Dynamic Channel Change Proposal For DOCSIS 1.1

Author: John T. Chapman

Rev 0.99 May 30, 2000

RFI-N-00021

Figure 6-29. Dynamic Channel Change Request

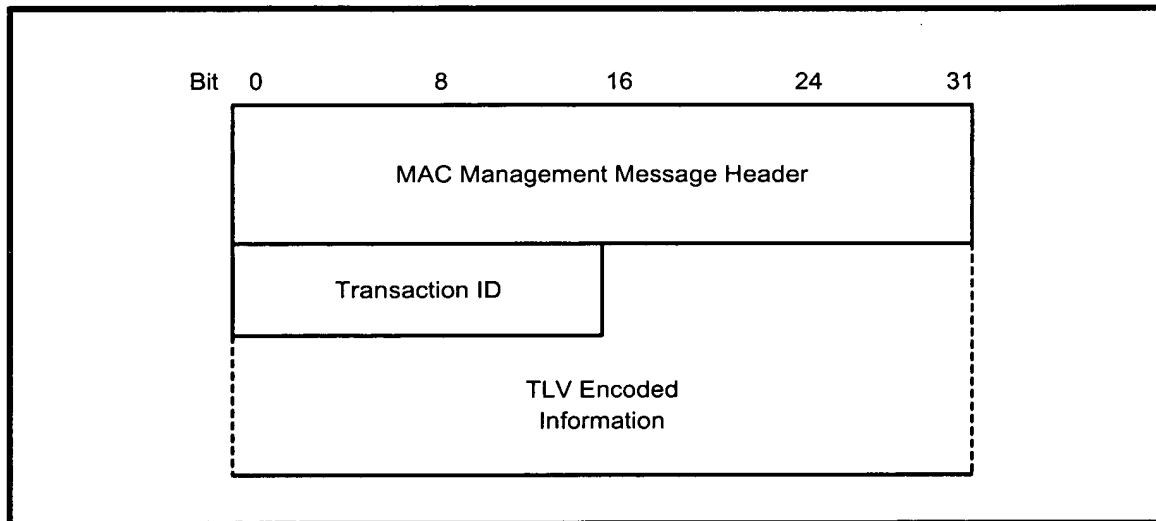
- **6.3.20 DCC-REQ**
 - Added HMAC digest
 - Added downstream channel ID to downstream parameters TLV
 - Combined SID, Classifier ID, and PHSI into sub-TLVs under Service Flow ID.

A CMTS MUST generate DCC-REQ message in the form shown in Figure 6-29 including the following parameter:

Figure 6-30. Dynamic Channel Change Response

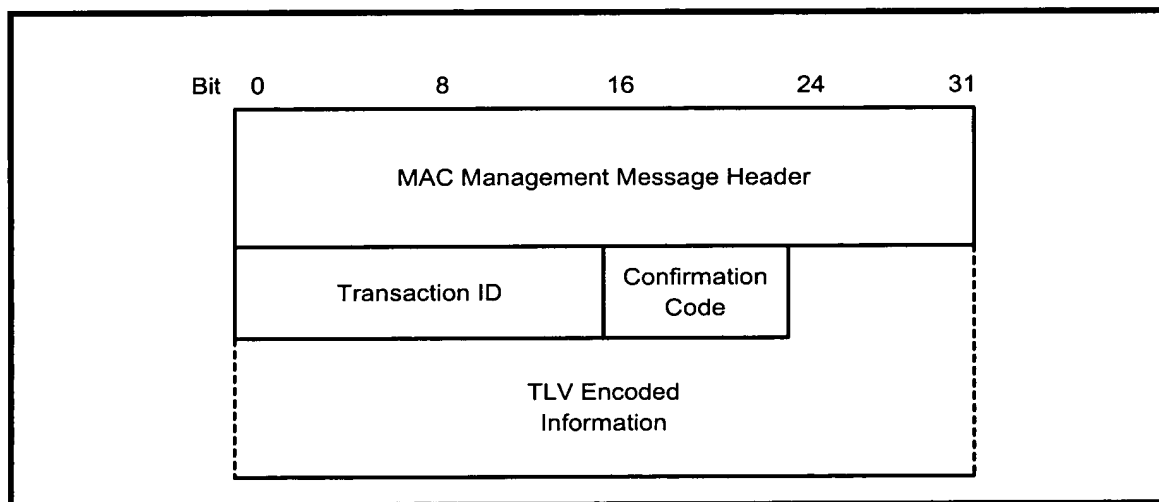
- Added Grant-Sync TLV per ECN-RFI-00009.
 - Fixed type in Interleaver dept. J parameter was missing.
- **6.3.21 DCC-RSP**
 - Added HMAC digest
 - Changed figure to allow TLV field.

A CM MAY support Dynamic Channel Change. If the CM supports Dynamic Channel Change, a Dynamic Channel Change Response MUST be transmitted by a CM in response to a received Dynamic Channel Change Request message to indicate that it has received and is complying with the DCC-REQ. The format of a DCC-RSP message MUST be as shown in Figure 6-30.

Figure 6-31. Dynamic Channel Change Acknowledge

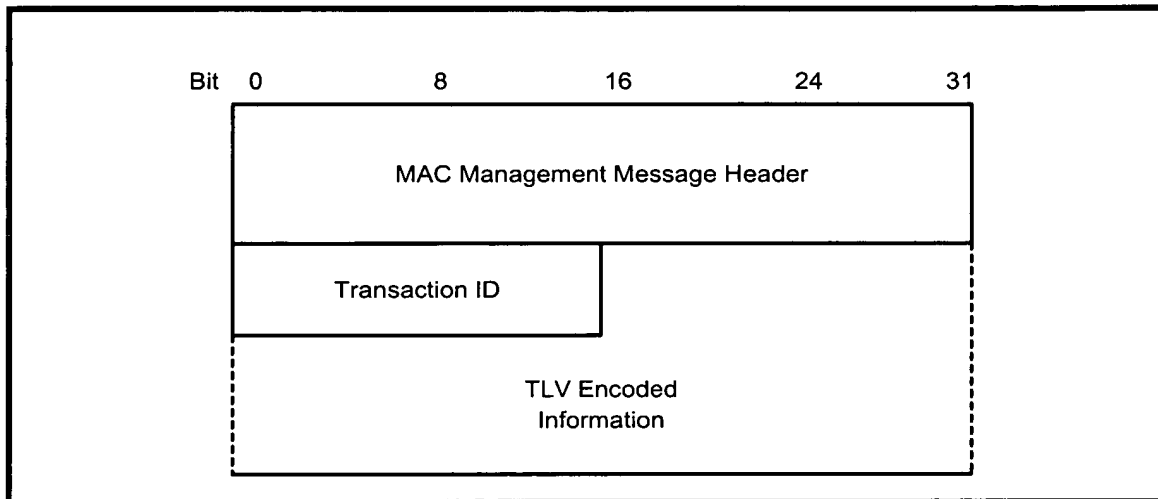
- Added a preface section which details required changes elsewhere in the I03 document
 - Noted updated needed to Figure 6-17
- **6.3.20 DCC-REQ**
 - Added Transaction ID.
 - Expanded Downstream parameters
 - Combined ranging TLV and configure TLV into one Initialization TLV
 - Removed SFID TLV.
- **6.3.21 DCC-RSP**
 - Added Transaction ID and Confirmation Code
 - DCC is now on old channel and new channel
- **6.3.22 DCC-ACK**
 - New message.

A Dynamic Channel Change Acknowledge **MUST** be transmitted by a CMTS in response to a received Dynamic Channel Change Response message on the new channel with its Confirmation Code set to arrive(1). The format of a DCC-ACK message **MUST** be as shown in Figure 6-31.

Figure 9-17. DCC Example Operational Flow

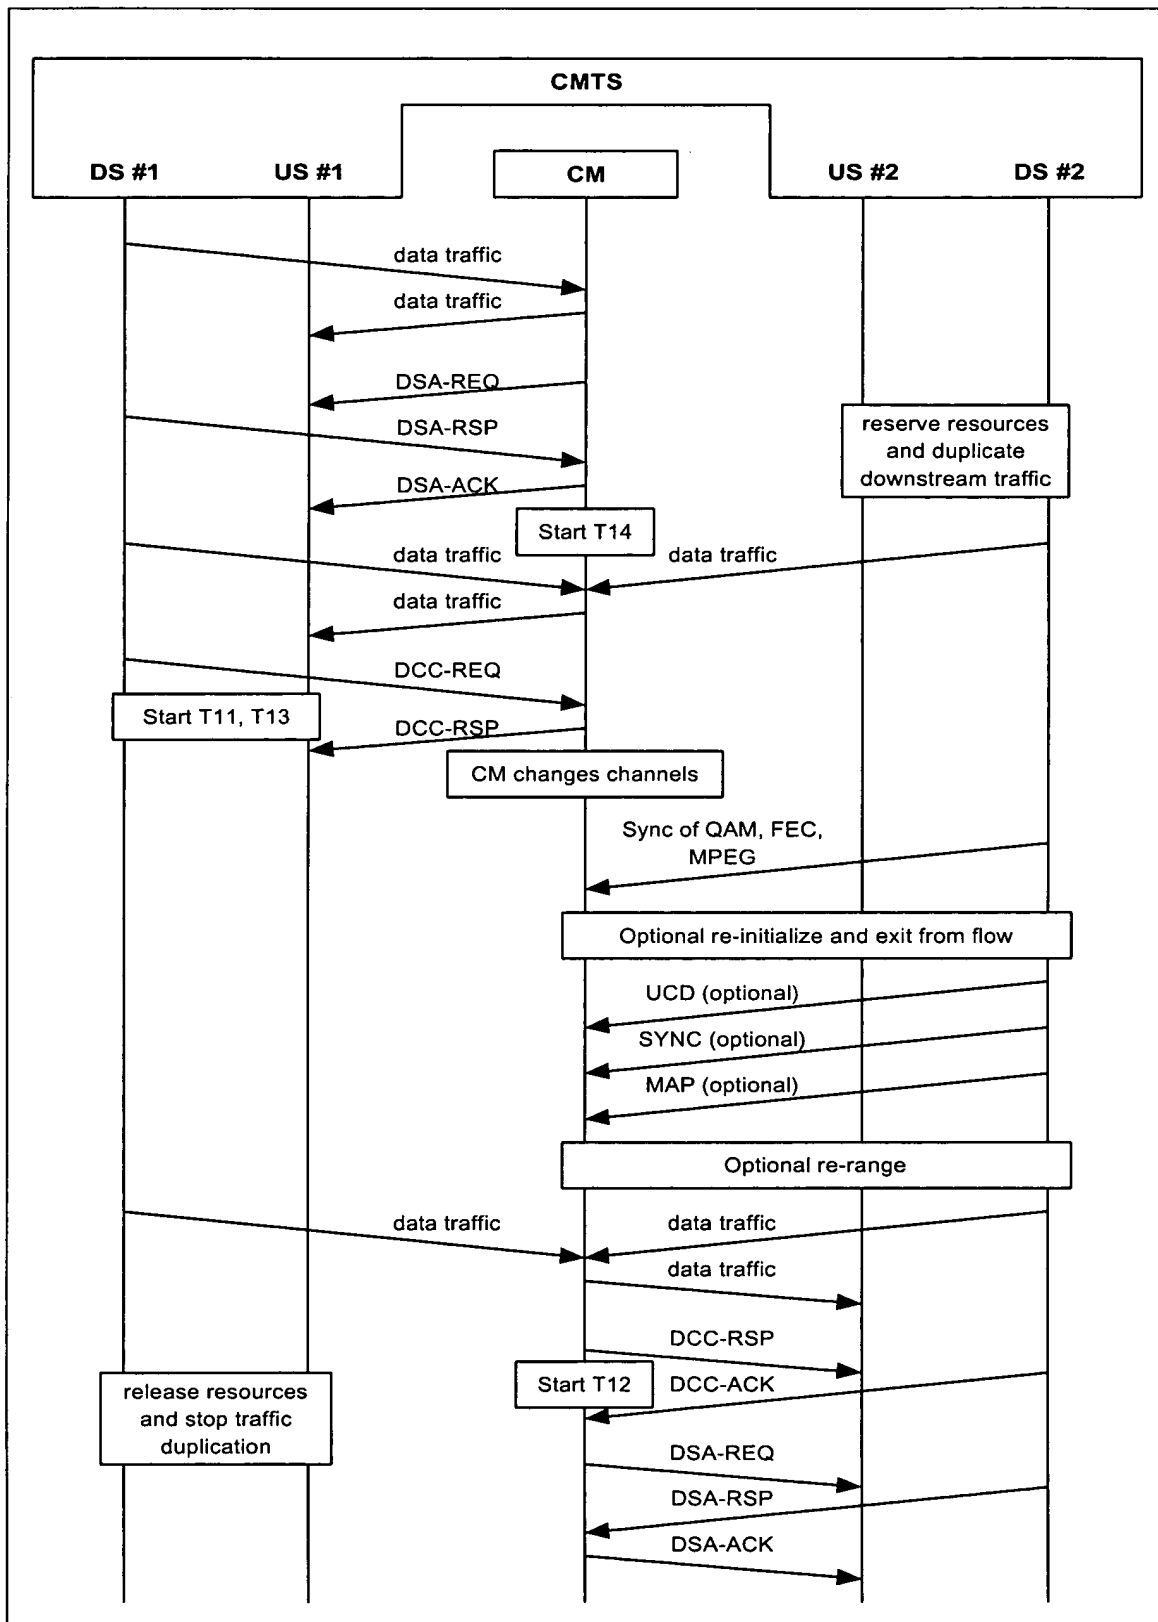
- Re-organized into 4 sub-sections to improve readability. Updated CMTS and CM state machines. Added a example transaction diagram.

Figure 9-17 shows an example of the use of DCC and its relation to the other DOCSIS MAC messages. In particular, this example describes a scenario where the CM attempts to allocated new resources with a DSA message. The CMTS temporarily rejects the request, tells the CM to change channels, and then the CM re-requests the resources. This example (not including all exception conditions) is described below. Refer to Section 9.2 for more detail.

Figure 9-21. Dynamically Changing Channels: CM View Part 2

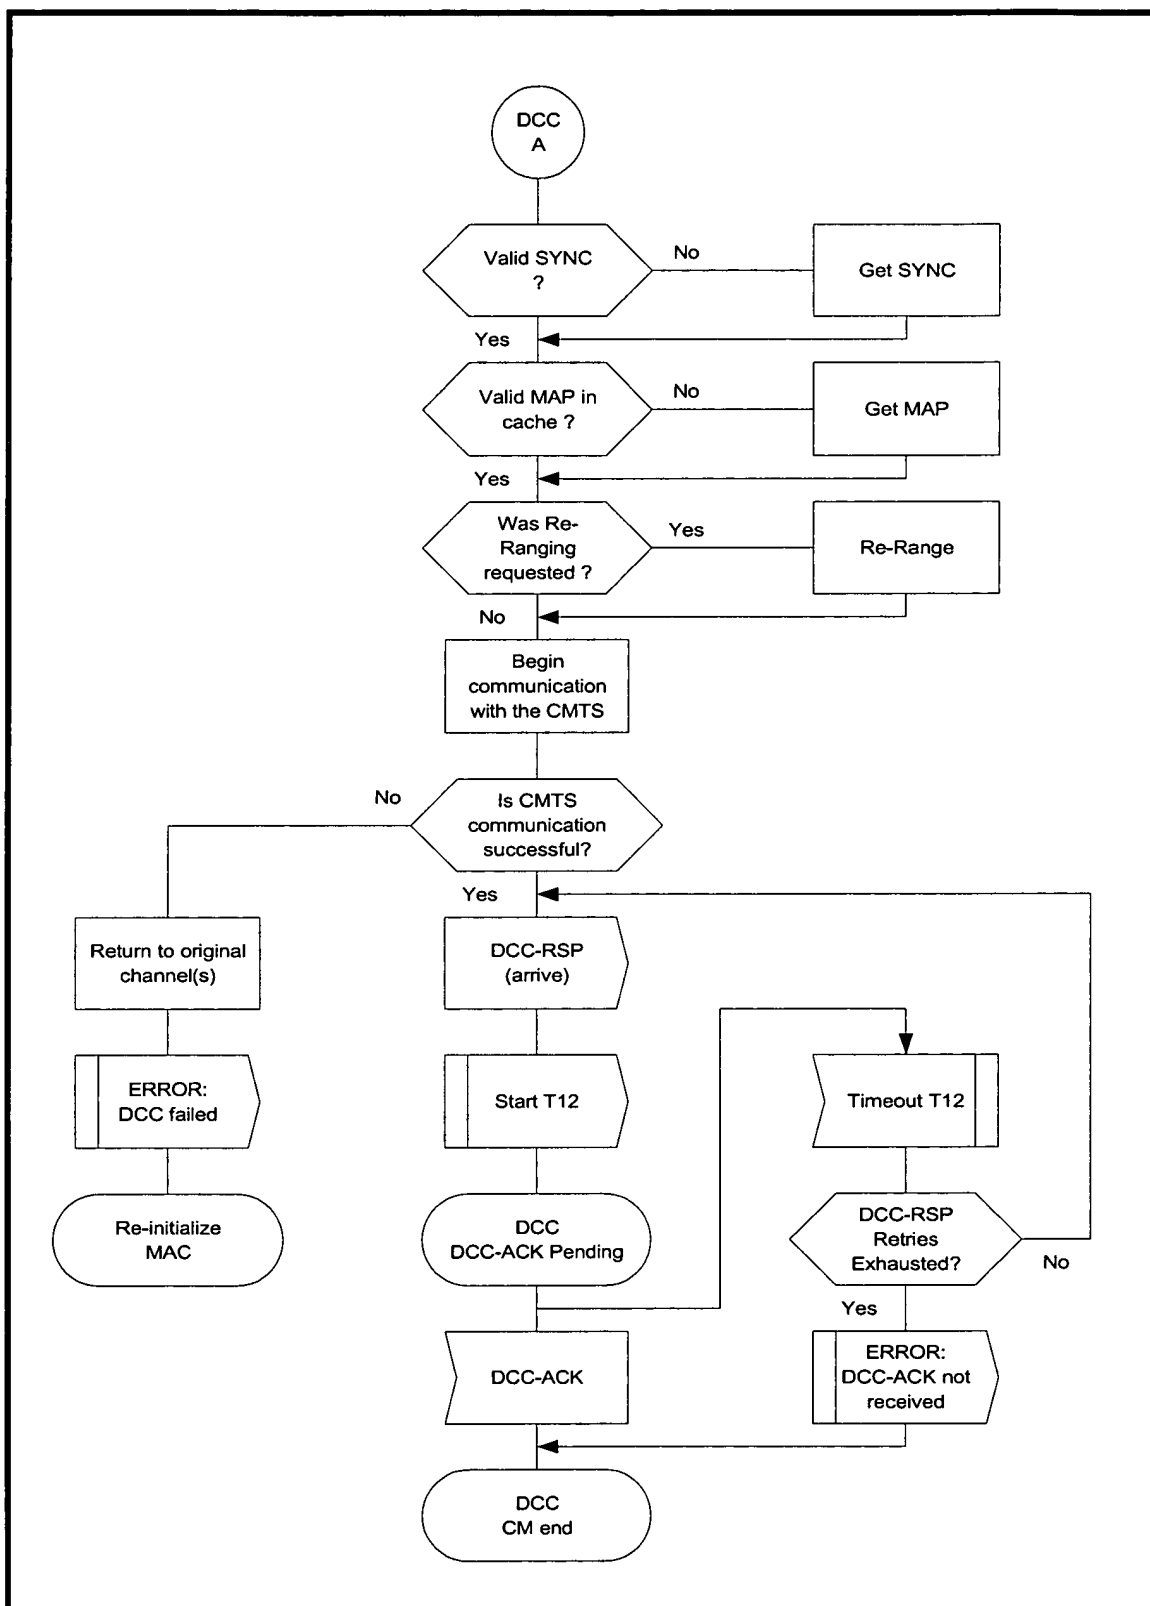
- **6.3.20 DCC-REQ**
 - Added SFID Substitution ID TLV back in.
 - Added Classifier ID Substitution TLV
 - Added PHSI Substitution TLV
- **Figures**
 - Figure 9-21, CM SM part 2 was down-rev. Update inserted.

Figure H-1. Single Downstream and Single Upstream Channels per CM

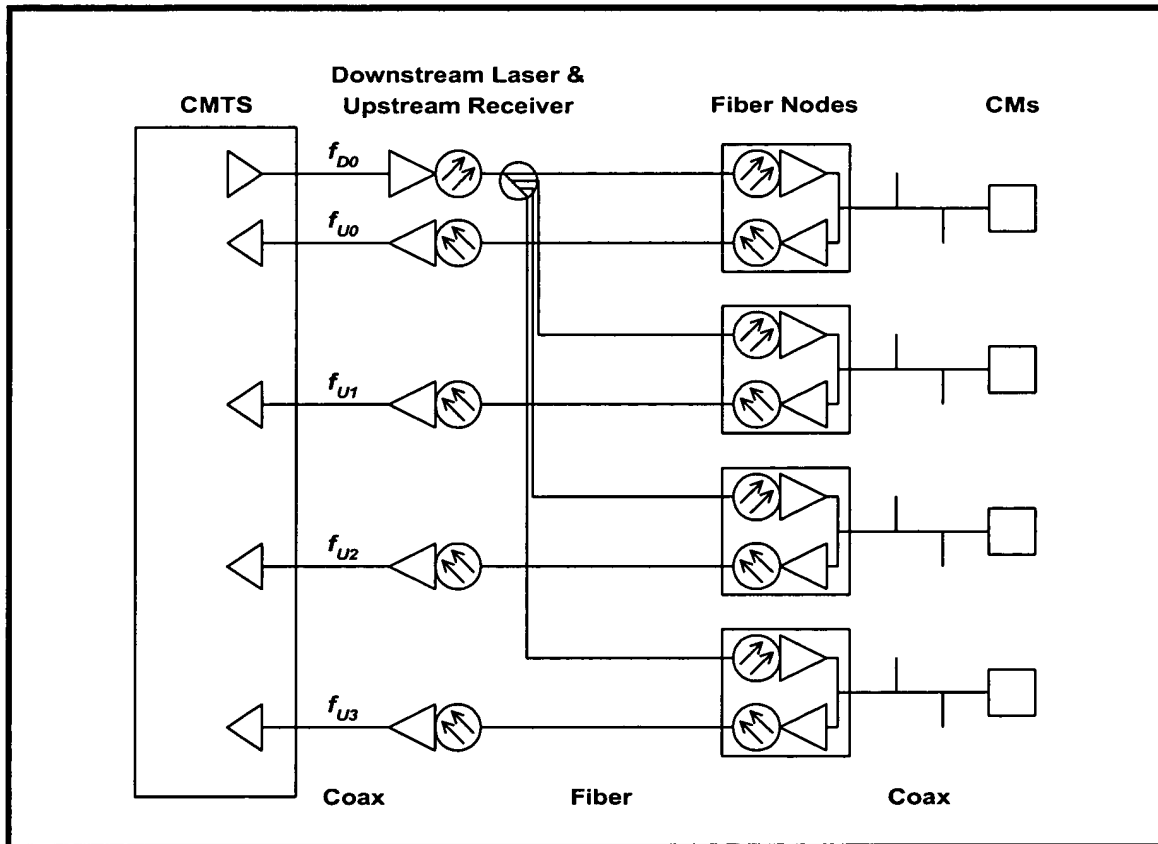
- Appendix H.1: Redrew the diagram. Clarified and updated text. Changed MUST to SHOULD on all upstreams being the same frequency. This is to allow for spectrum management techniques.

This section presents an example of a single downstream channel and four upstream channels. In Figure H-1, the four upstream channels are on separate fibers serving four geographical communities of modems. The CMTS has access to the one downstream and all four upstreams, while each CM has access to the one downstream and only one upstream.
